APPLICATION FOR AMENDMENT TO PERMIT

Re-review for new shoreland zoning restrictions  
Make int/ext changes to windows (design & locations)

BUILDING PERMIT REPORT

REASON FOR PERMIT: To construct addition code 12  
12' x 26' deck 14' x 14'

PLAN OF WETLAND DELINIATION FOR JULIE HOWISON 262 CAPISIC STREET PORTLAND, M-E

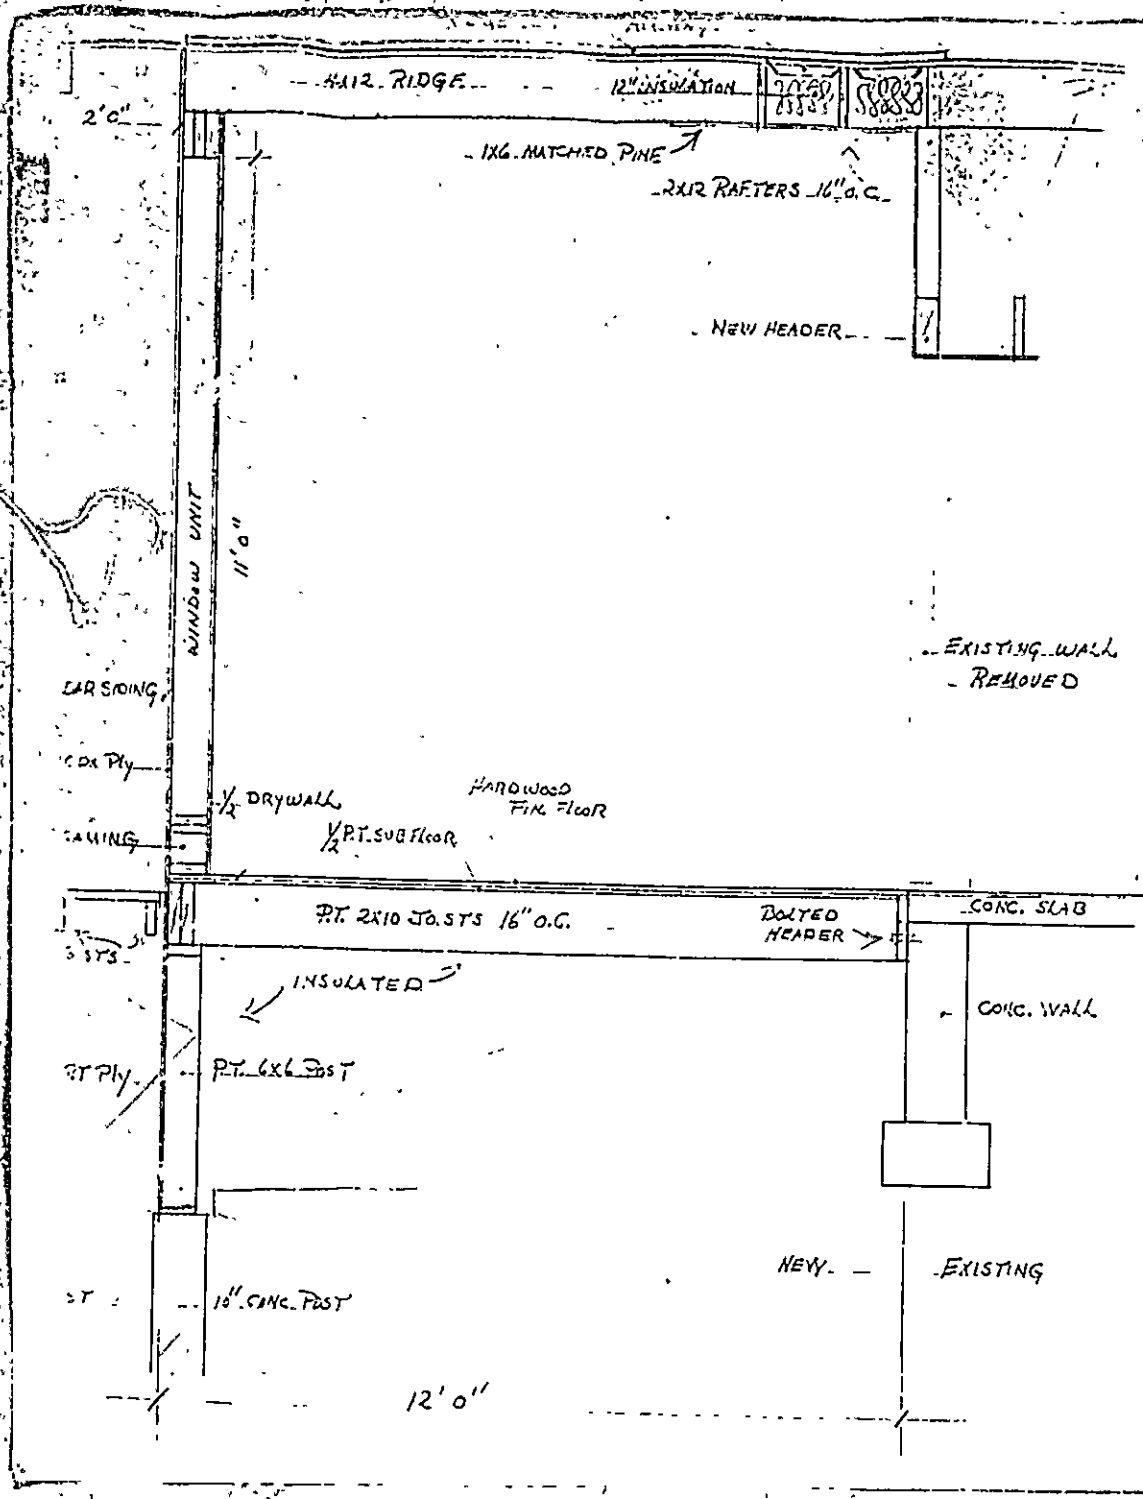
The city definition of fresh water wetland is the same as the D.E.P. definition. Our interpretation is that the fresh water wetland near your house is not regulated because it is less than ten acres in size. Therefore, there is no city setback requirement and no D.E.P. setback from the fresh water wetland. The Army Corps of Engineers only has jurisdiction if you do work in the wetland.

The limiting factors for your addition are the location of the sewer easement, and the R-P Zone line. It appears on the City zoning map that the zone line, as it crosses your lot, follows the near side of the sewer easement. This may be subject to interpretation by the Code Enforcement Officer.
